# **Environmental Impact Statement for the License Renewal of the Columbia Fuel Fabrication Facility in Richland County, South Carolina**

Final Report

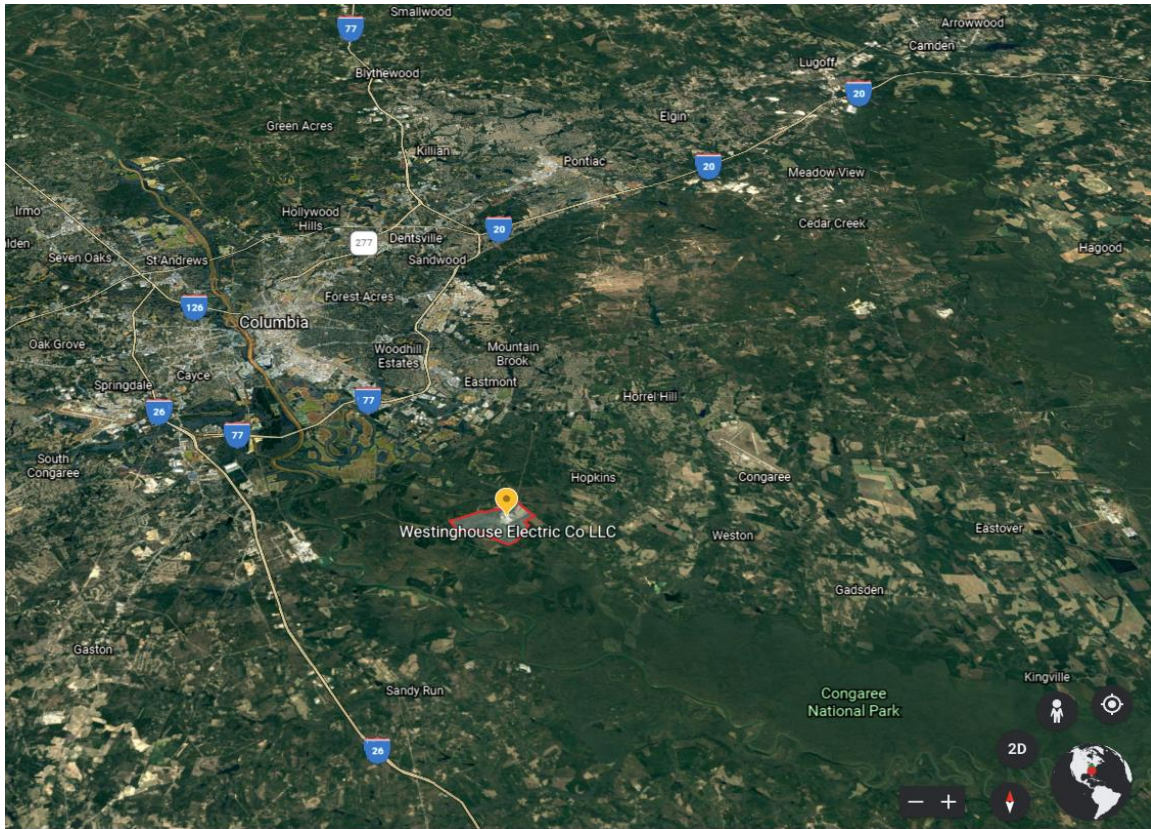
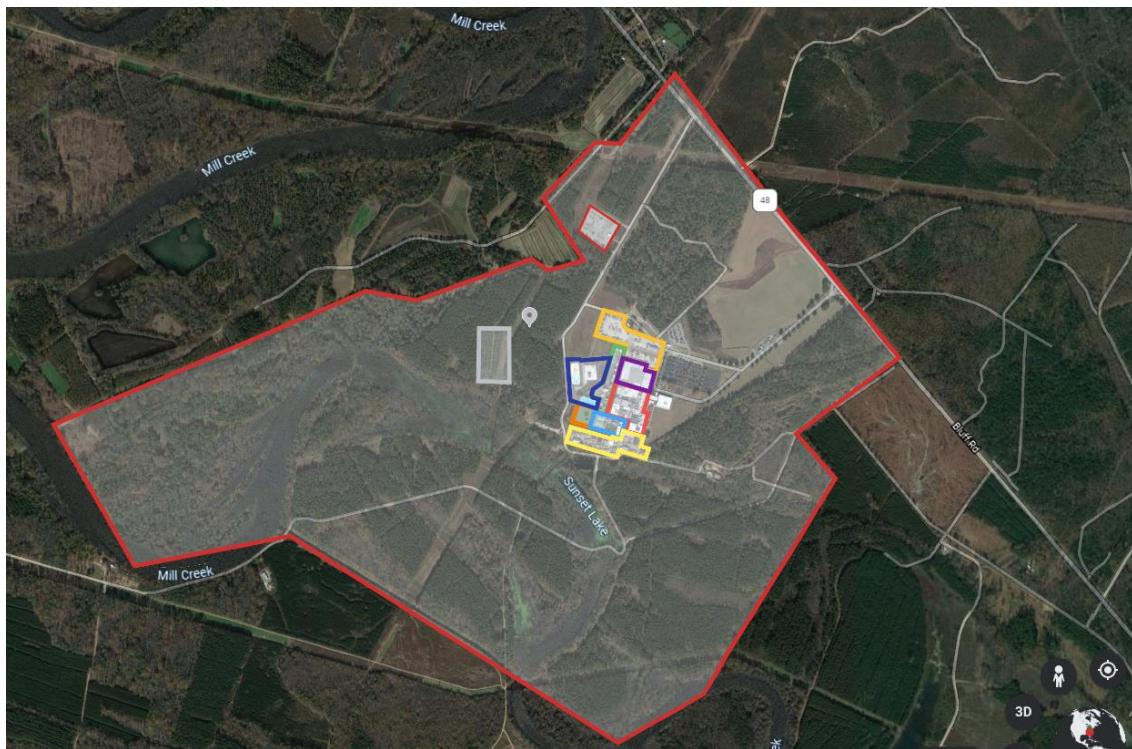
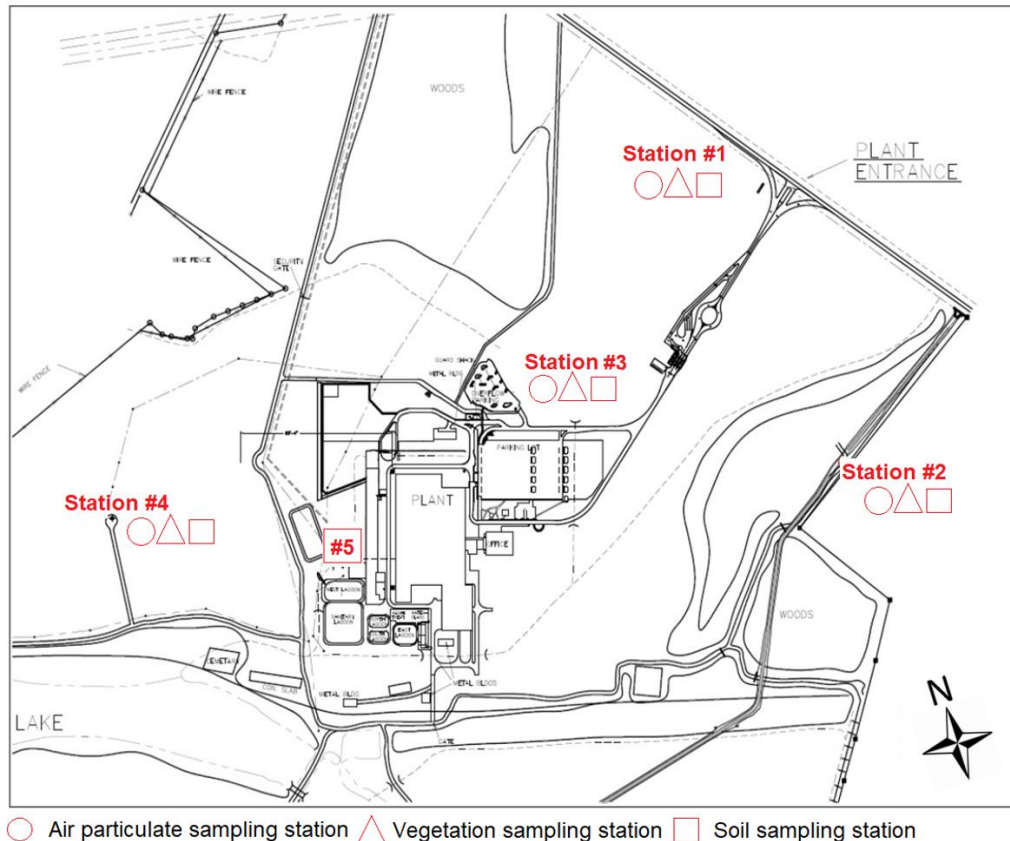
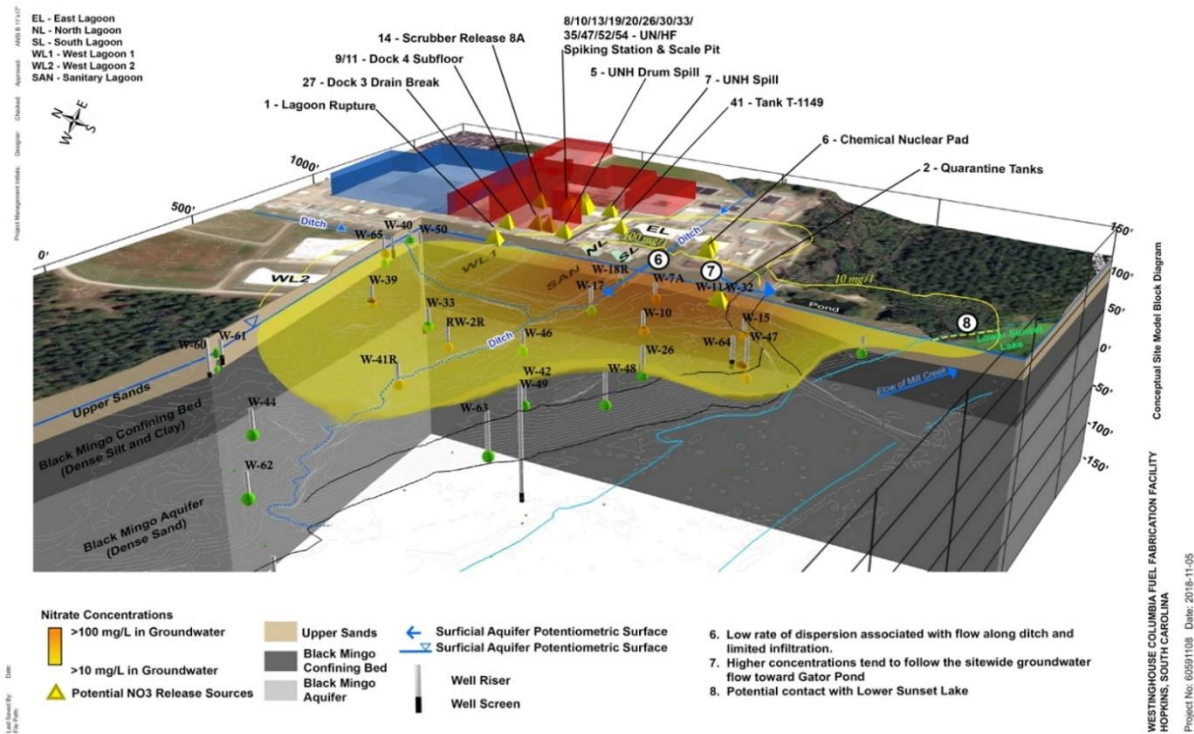
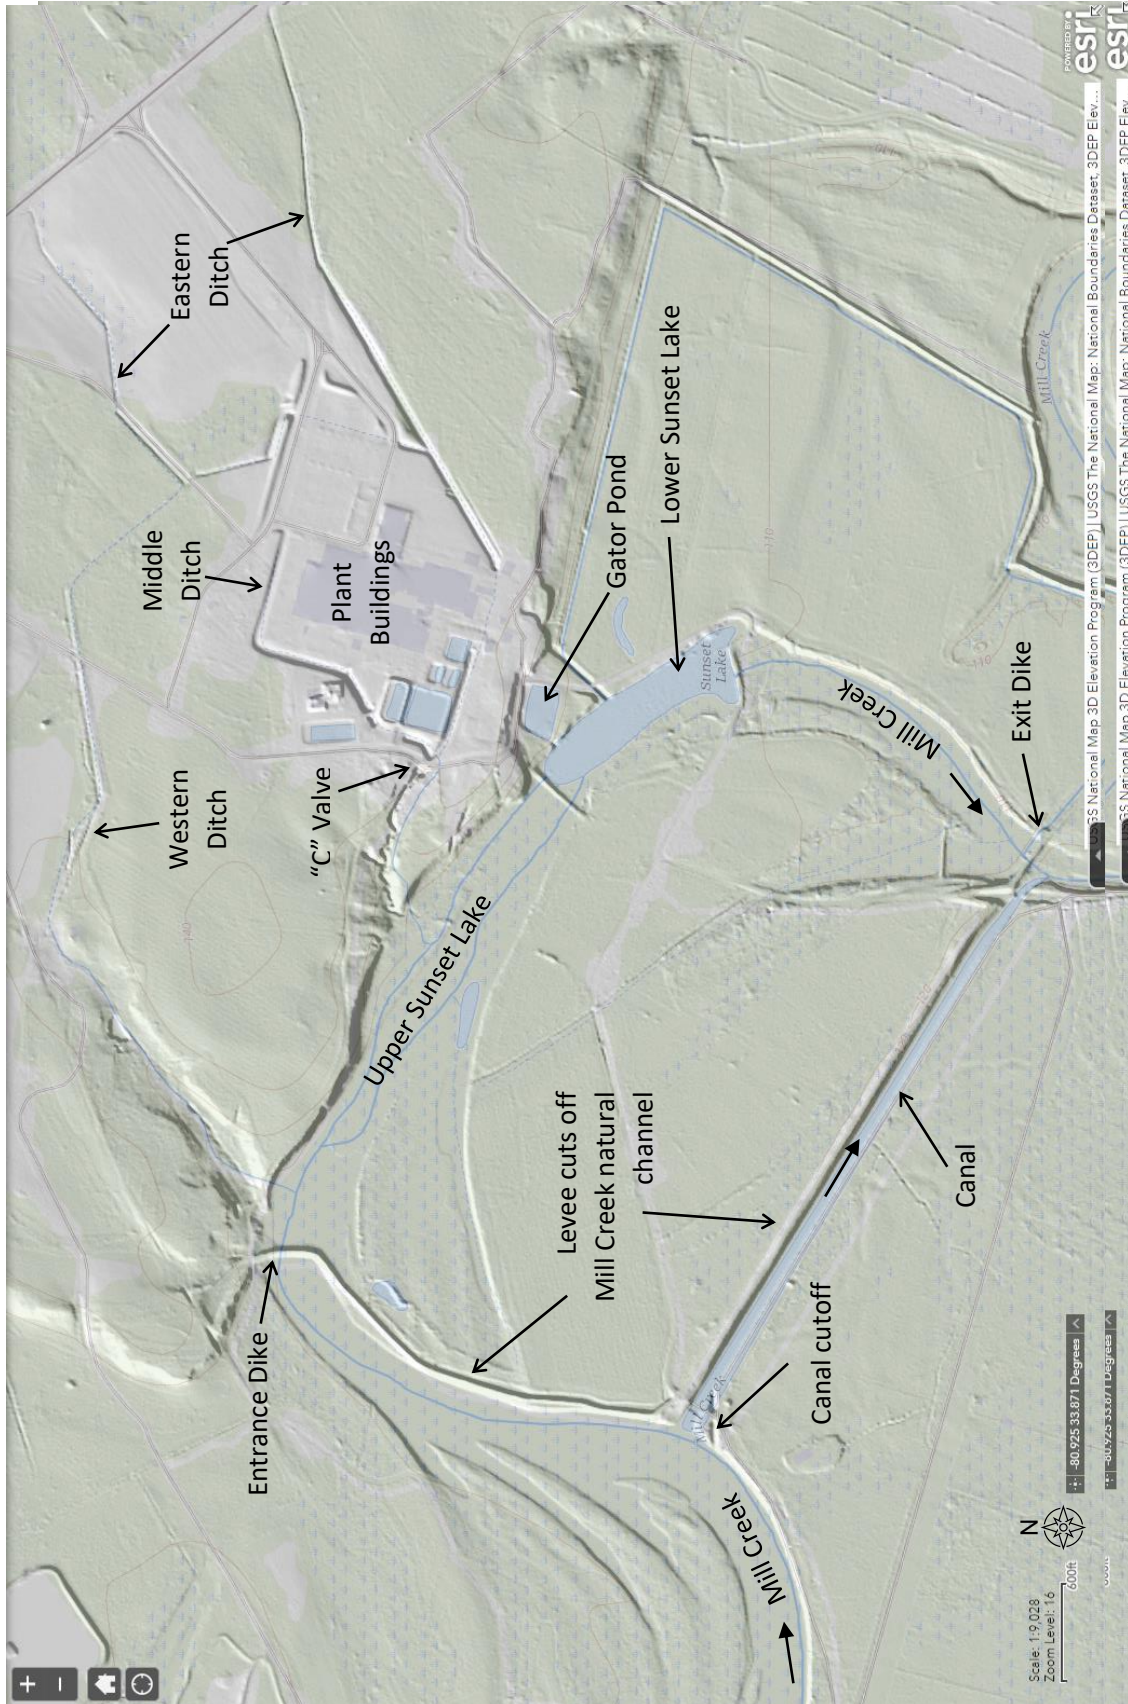
**Comment:** 4. Many of the included maps and figures lack critical elements such as legends and/or scale bars (e.g., Fig 2-1, 2-2, 2-4, 2-7). Fig 2-10, while useful, has no orientation

information. For Fig 3-8 the reader must assume that in the Plan View, up is North. For the maps and figures that are missing critical elements include updates in the Final EIS. (34-1-15 [Fite, Mark])

**Figure 2-4 CFFF Operational Units (Source: Modified from Google Earth)**

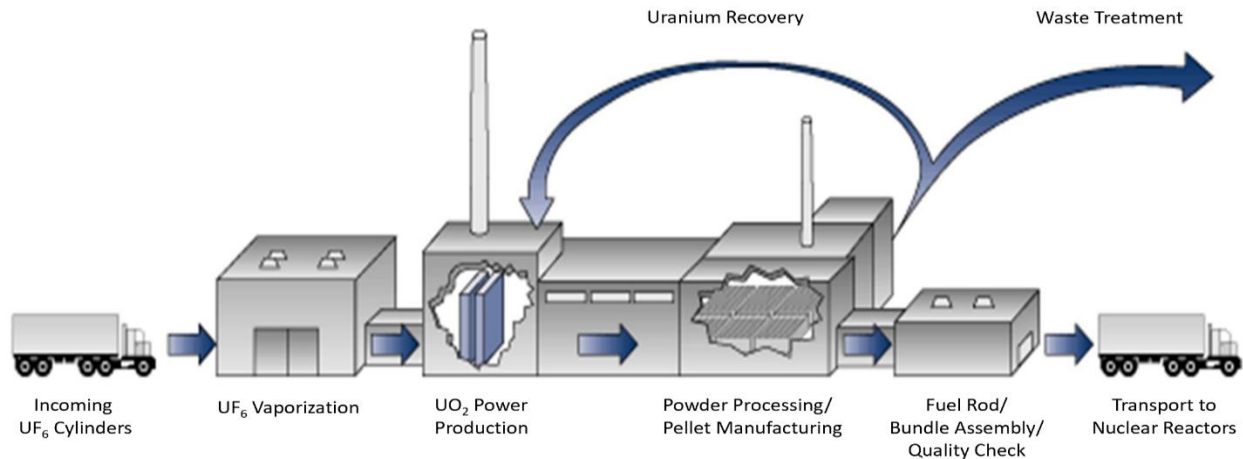
Current Wording: "Figure 2-4 shows the location of the six onsite lagoon storage basins in the West Lagoons Area, Wastewater Treatment Area, and Sanitary Lagoon Area."

Suggested Wording: "Figure 2-4 shows the location of the ~~six~~ **five remaining** onsite lagoons and the former location of the East Lagoon. ~~storage basins in the West Lagoons Area, Wastewater Treatment Area, and Sanitary Lagoon Area.~~"

**Figure 2-6 Uranium Recycle and Recovery Services Process Streams (Source: WEC 2021-TN7170)**

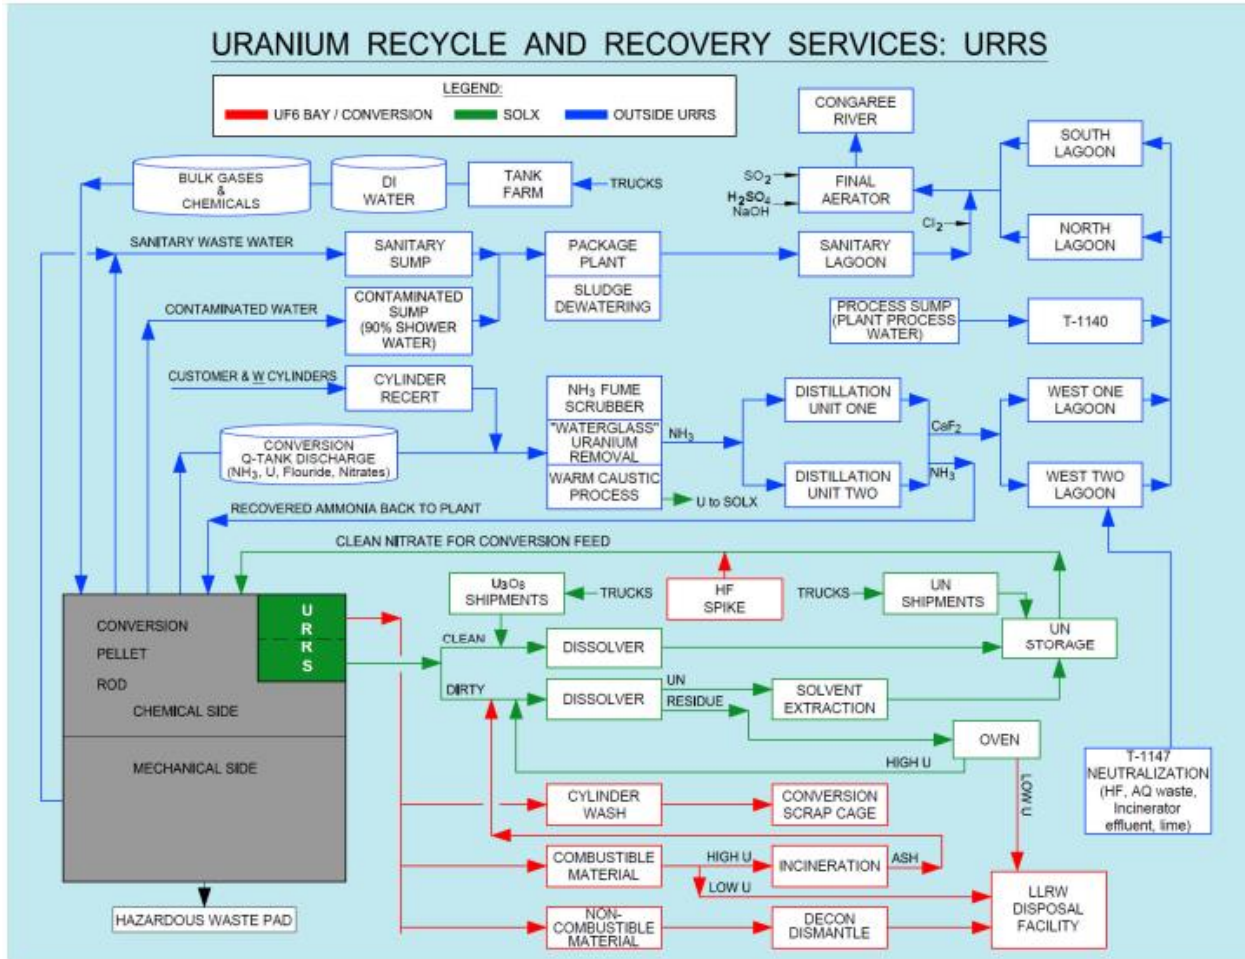
Line: Figure 2-6

Current Wording: Figure 2-6 "URRS Process Streams (Source: WEC 2019- TN6510)

Suggested Wording: Replace Figure 2-6 with updated figure in Enclosure 3.

**Figure 2-8 Surface Water and Sediment Sampling Locations (Source: WEC 2019-TN6423)**

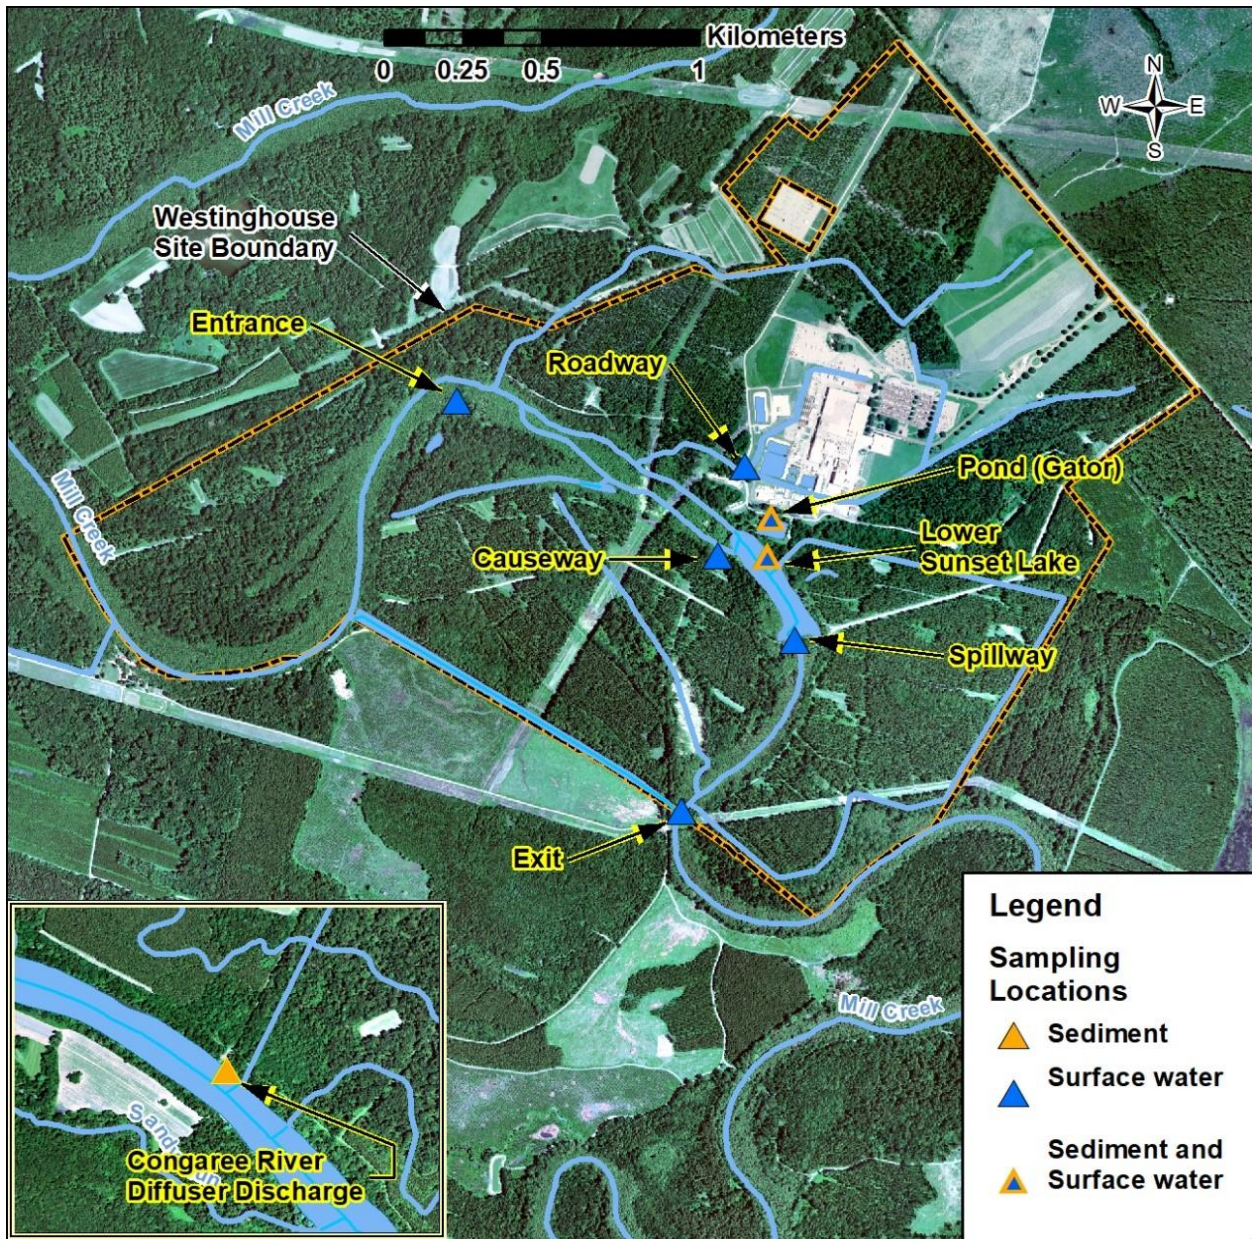
**Comment:** pp 2-20, Figure 2-8: Due to deficiencies in available contaminant distribution data, additional soil and surface water sampling locations should be sited for the smaller streams, in conjunction with the proposed groundwater sampling, to establish if these are pathways into the larger Mill Creek/Sunset Lake water systems. Flow in these streams may be intermittent where surface water sampling would need to be timed with rainfall events, but soil/pore sampling can still be conducted. (39-10 [Ghanem, Sahar] [Plauche, Mary])

Figure 2-9 Groundwater Well Locations at the CFFF Site (Source: WEC 2021-TN7170)

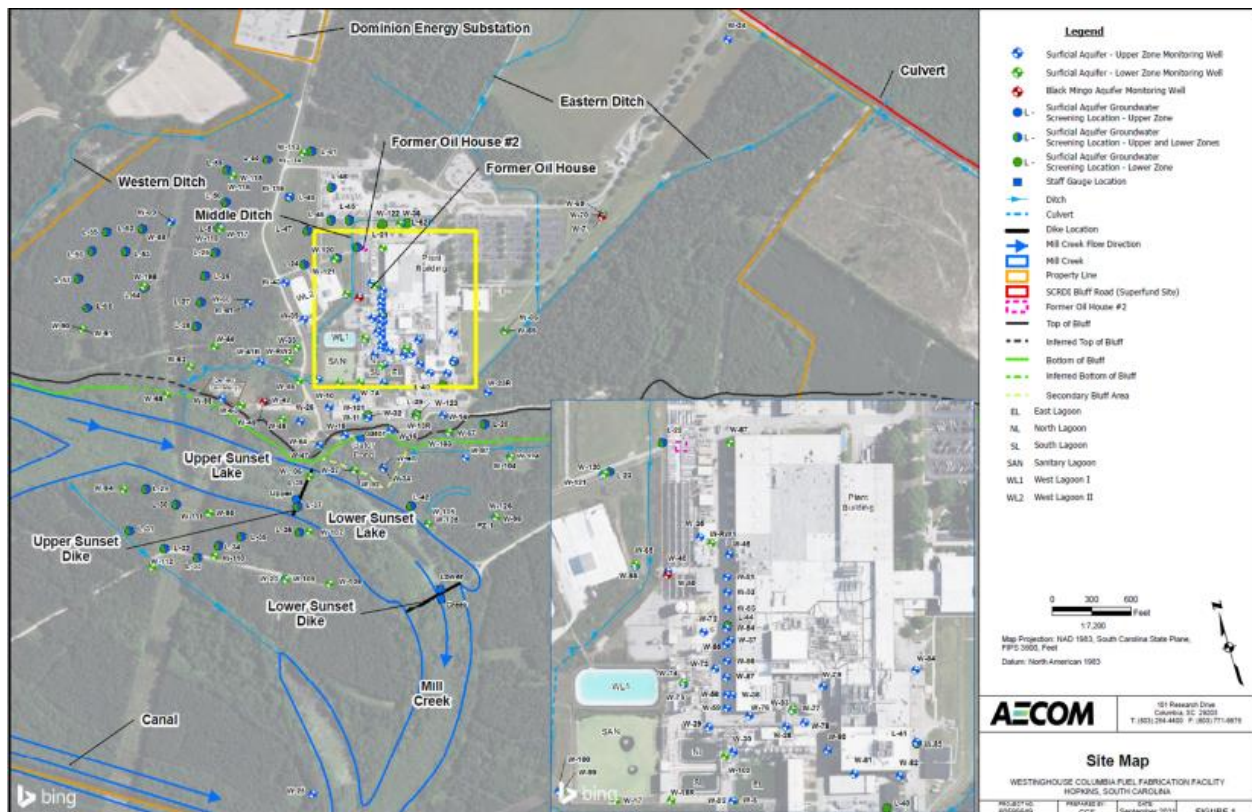
Line: Figure 2-9

Suggested Wording: Suggest replacing Figure 2-9 with Enclosure 4.

**Figure 3-4** Location Map of Earthquake Epicenters for Earthquakes between 1900 and September 1, 2020, for the South Carolina Region (Source: USGS 2021-TN6951). The geographic bounding box for the earthquake search is as follows: Latitude 32.1 – 35.7N and Longitude 79.3-83.5W.

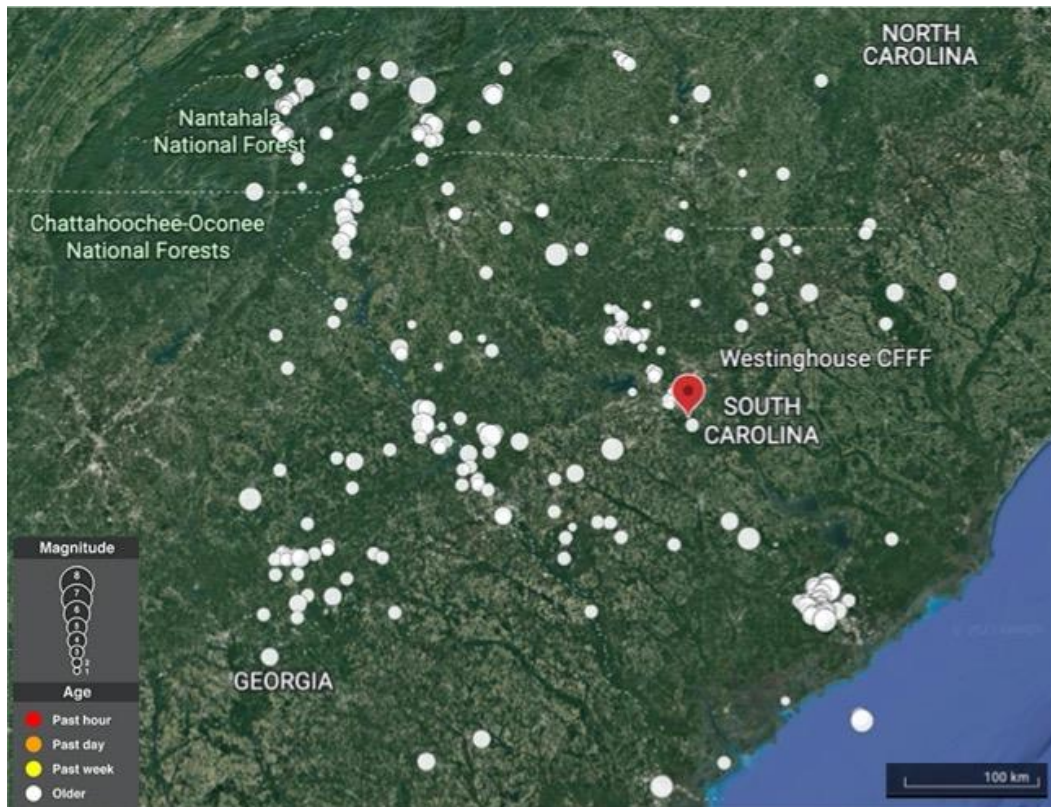
**Comment:** The search area or search radius used for the USGS earthquake catalog is not listed or defined (Lat/Long boxes or similar), nor does the included location map include a scale bar (Fig 3-4). The USGS peak acceleration map cited in the text could be helpful, especially if it was cropped to the region in question and the CFFF site located. The current map could be combined with the earthquake epicenters plotted. The earthquake magnitude distribution has

**Response:** *The NRC staff will revise Section 3.2.3 of the EIS to provide additional clarity and detail as requested by the commenter, including the revision of Figure 3-4.*
